Product Change Notice

Issued May 12, 2025, Revised July 22, 2026

Products Affected: G60P Guard Series
Type of Change: Change of product specifications, Country of Origin
Reason for Change: Change in product manufacturing location
Affected Models: G60P

Previous Design Revision:

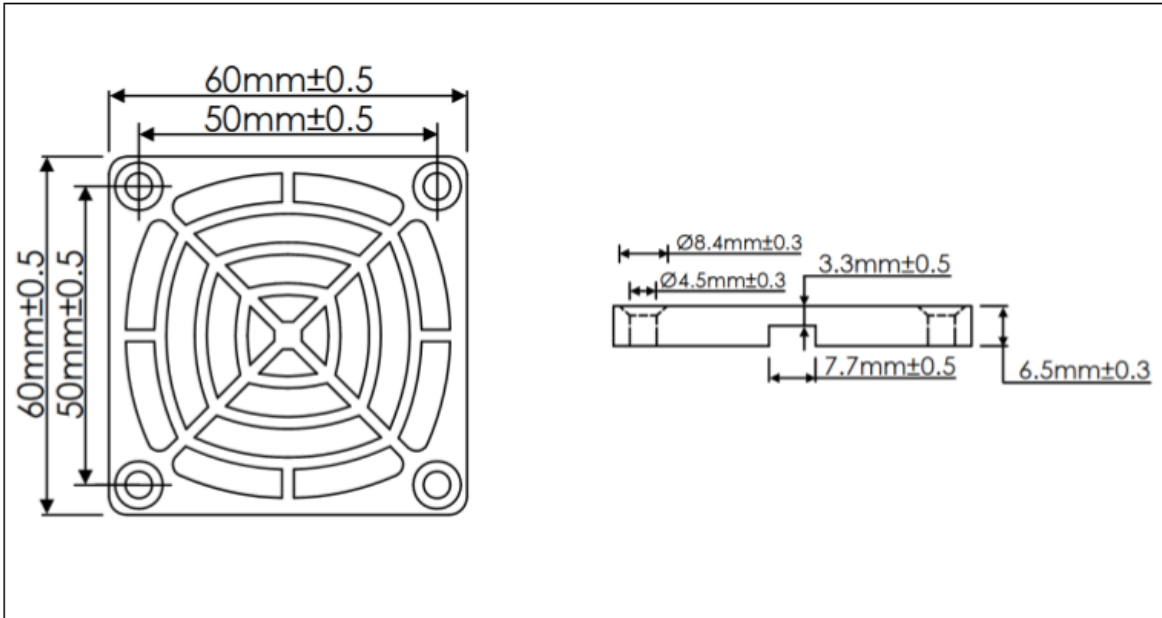
Production of this product series was moved to Taiwan based facilities, and the design was revised to match manufacturing requirements in the new facility. New specifications have been issued for this product, impacting mechanical dimensions. All G60P production lots completed after August 1, 2026 will use the updated design. Production of the previous G60P design is available by special order. For customers wishing to purchase the previous design revision, contact Orion Fans to obtain quotations with minimum order quantities for new production will be provided, if required.

Component	Original Design Specification	New Design Specification*
Countersunk Mounting Hole Diameter	8mm±0.3	8.4mm±0.3
Countersink Angle	65°	105°
Guard Notch Width	7.8mm	7.7mm±0.5
Guard Thickness	6.5mm	6.5mm±0.03
ABS Plastic Flame Rating	UL94 V-0	UL94 HB
Country of Origin	China	Taiwan

Description	Plastic Fan Guards make it easy to protect personnel from injury while offering minimal airflow obstruction and a stylish design.
Guard Material	Plastic - Reinforced ABS Polylac PA-757, UL Approved Material E56070, Rating UL94 HB
Mounting	Ø4.5mm mounting holes, Compatible with 90° Countersink Fasteners.
